UNITED STATES PATENT AND TRADEMARK OFFICE

APPLICATION NO.	FILING DATE	FIRST NAMED INVENTOR	ATTORNEY DOCKET NO.	CONFIRMATION NO.
10/524,812	02/18/2005	Horst Schulz	ZAHFRI P723US	1653
20210	7590	04/13/2006	EXAMINER	
DAVIS & BUJOLD, P.L.L.C. FOURTH FLOOR 500 N. COMMERCIAL STREET MANCHESTER, NH 03101-1151			MILLS, DANIEL J	
			ART UNIT	PAPER NUMBER
			3679

Office Action Summary	Application No. 10/524,812	Applicant(s) SCHULZ ET AL	
	Examiner Daniel J. Mills	Art Unit 3679

DETAILED ACTION

A. W. HALLBERG
LAVATORY FIXTURE
Filed July 8, 1925

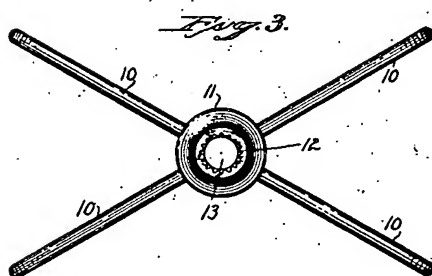
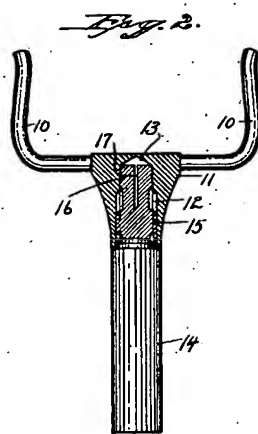
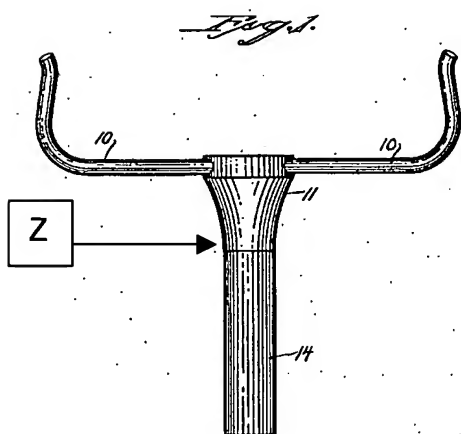
Regarding claim 13, Hallberg discloses a shaft-hub connection comprising a shaft (14) comprising; a first centering segment (16) located at a free end of the shaft having a first diameter, a second centering segment (C) axially spaced from the first centering segment; an intermediate toothed segment (15) located axially between the first and second centering segment, and the first centering segment and the intermediate toothed segment as well as the second centering segment have a same second diameter which is larger than the first diameter of the front centering segment; a hub (11) having a stepped aperture formed therein for receiving the shaft in an axial direction, the aperture consisting essentially of a first segment (13) having a first aperture diameter; a second segment having a second aperture diameter (12) which is larger than the first aperture diameter; and wherein the diameter of the first segment (internal diameter of the splines) is smaller than the diameter (root diameter of the splines) of the intermediate central toothed segment and when the shaft is inserted into the aperture to form the shaft-hub connection, the intermediate central toothed segment is forced into an overlapping axial engagement with the smaller diameter of the aperture. Hallberg fails to disclose that the intermediate central toothed segment is forced into an overlapping axial engagement with the smaller diameter of the aperture

cut a counter profile in the hub and form a positive interference fit between the central toothed segment and first segment of the hub.

Examiner notes that knurl-splined shafts which forced into a bore to form a interference fit with a counter profile are well known, and that wheel studs are but one of many examples.
